Western Bay of Plenty District Council

Plan Change 72 Rangiuru Business Park

Planning Report

March 2016

11.6 Roading Layout and Land Use

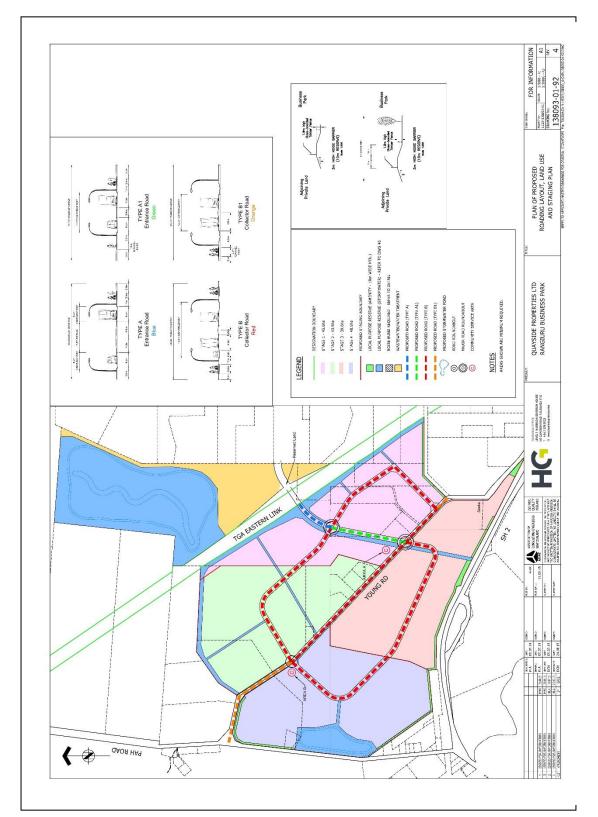
The submitters raise a valid point about the clarity of the notation on Map 6: what is the land reserved for? This should be amended for clarity, but it is not necessary to include on every map. Each map has a specific purpose related to particular types of infrastructure. Thus it is only necessary to amend the "Roading Layout, Land Use and Staging Plan" (Map 6).

Hebland Holdings (13.2) oppose the change in PC72 and submit that the RBP should adjoin the Railway land without any amenity reserve.

An amenity reserve around the perimerter of RBP is important as a buffer to adjoining land uses. This is equally important along the Railway because the Te Puke Highway immediately adjoins the Railway. That highway is an important tourist route, and is also used extensively by local traffic. Hebland raise a valid point that the opportunity to use the rail corridor for access to transport goods should not be closed off. Their reasons align with the Operative Plan as it affects this part of their land.

That Appendix 7 Map 11.6 "Roading Layout, Land Use and Staging Plan" be amended by changing the wording "Reserved Land" to "Land reserved for possible roading link to Te Tumu".

That in Appendix 7, Map 11.6 Roading Layout and Land Use, the "Local Purpose Reserve Amenity (10m wide minimum)" as it adjoins the Hebland property be retained as in the Operative Plan.

- 1. Change wording on the diagram as follows: Reserved Land-Land reserved for possible roading link to Te Tumu
- 2. Change the Local Purpose Reserve adjoining the Hebland property to be the same as in the Operative Plan.
